ADDENDUM NO. 2

Subject: ITT Invitation to Tender No. FP802-170324

Title: Ladder and Platform Refurbishment - Straight of Canso Range Towers

Location: Mulgrave and Port Malcolm, Nova Scotia

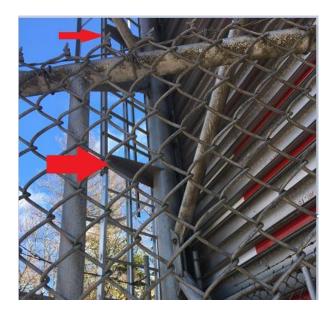
Removal of ladders. Do you want the welded brackets holding the ladders removed? See below

Please remove the brackets along with the ladders. The aluminum leg thickness is very thin however, so do not remove the weld or any leg material as it may compromise the structural integrity of the leg.
